AND IN THE MATTERS OF An application under s88 to
discharge contaminants to water,
land and air associated with the
proposed long-term upgrade and
operation of the Featherston
Wastewater Treatment Plant

APPLICANT South Wairarapa District Council

EVIDENCE IN CHIEF OF DR LEE BURBERRY ON BEHALF OF WAIRARAPA REGIONAL PUBLIC HEALTH

2 May 2019

Figure 1: Most current soil map of the proposed effluent disposal area showing gley soil of the Ahikouka deep silt loam family (blue shaded area; Tait_42 label) covers the site. Note: actual site (A & B) boundaries are approximate and for illustration purposes only.

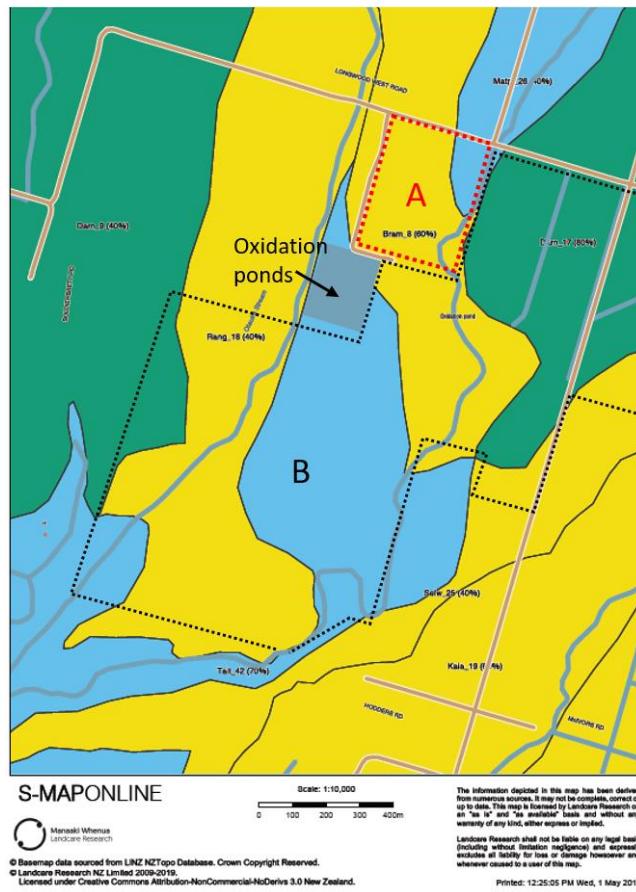
18. According to Landcare's S-map soil report, Ahikouka silt loam is classified as a typic recent gley (not a brown) soil that exhibits poor drainage properties and is highly vulnerable to bypass flow effects (through macropores) of both water and contaminants.
19. The most recent S-map is provided as Figure 1, below. It shows the proposed land-based effluent disposal area spans across at least 4 different mapped soil families. The blue shaded region marks Ahikouka deep silt loam that is slowly permeable, but more significantly is recognised as being vulnerable to bypass flow, therefore high risk of facilitating microbial transport via macropores. Similarly, green shaded areas map Carterton very stony silt loam, which is also described as being vulnerable to bypass flow effects.

20. For the purpose of conducting a conservative pathogen risk assessment, I consider it is more appropriate to assume microbial removal rates for a gley soil cover at the effluent disposal site, not a brown soil cover.

21. ESR (2010) report a virus (pathogen) removal efficiency of 1.0 log/m for gley soils, versus 2.0 log/m for brown soils (such as assumed by GWS Ltd.). By this token, for the same 0.5 m vadose zone thickness assumed by GWS Ltd. and application of 1000 bacteria/L or 10 viruses/L, the concentration of pathogens entering the groundwater might reasonably be:

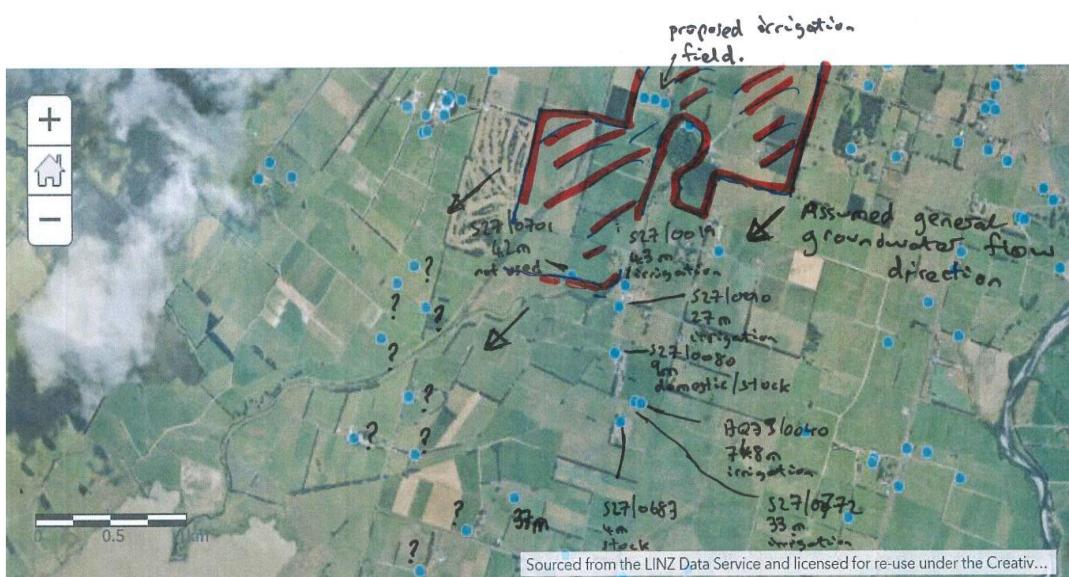
32. Using well S27/0080 as a reference environmental receptor then from the results of the microbial transport assessments I make above, whilst the risk is perceivably low, I would not rule out potential for the water quality of this well to be at risk of being impacted by pathogens from the proposal.

Figure 2: NZ geological map (GNS QMap) of the area of interest showing site is underlain by alluvial gravels deposited during the last ice age.

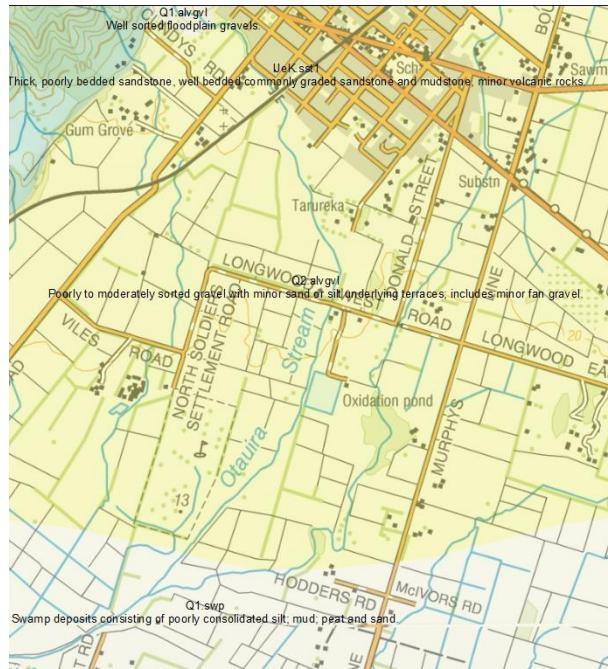
45. Regarding the assumptions of the hydraulic properties of the receiving aquifer. According to GNS' Geology Qmap (see my Figure 3, below) the site is underlain by gravel alluvium associated with the Tauherenikau fan and which was deposited at the end of the last ice age (Q2).

46. When calibrating a groundwater model of the Lower Wairarapa valley, WRC (2010) determined the horizontal hydraulic conductivity K_h of sediments of the Lower Tauherenikau fan to be in the range 16.4-17.3 metres/day (see Table 1 appended below). A value of 12 metres/day is assumed in the AEE. It is in the right ball park and I accept suitable for the purpose evaluating groundwater mounding effects.
